Flange for SCHUNK Manual
Change System FWS
(fits in one orientation only)

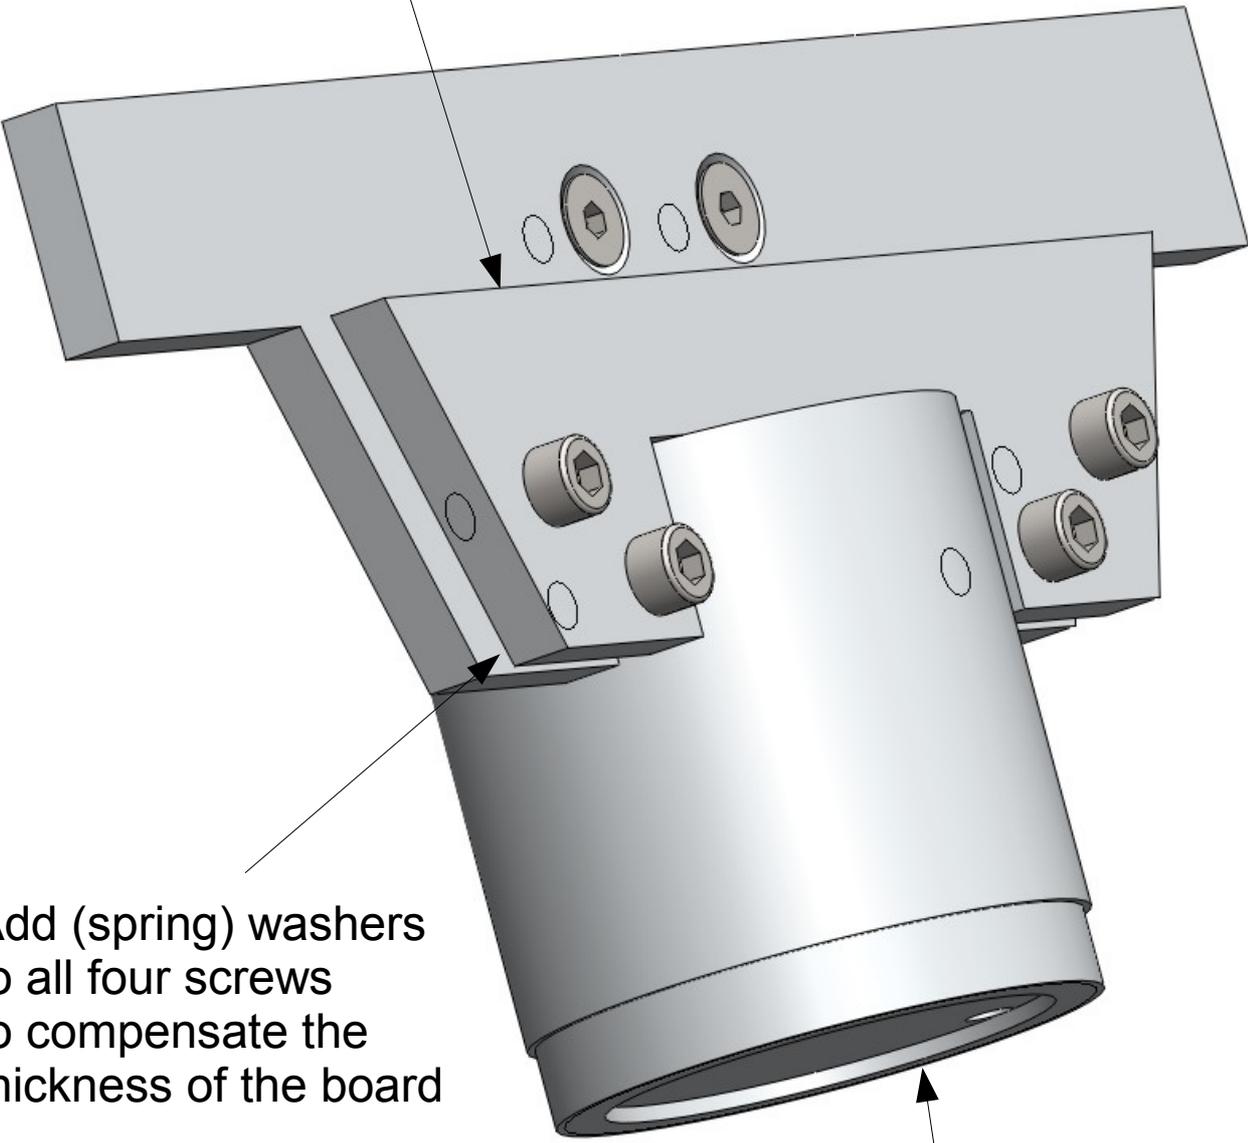
Clamp checker board
inside the gap

Add (spring) washers
to all four screws
to compensate the
thickness of the board
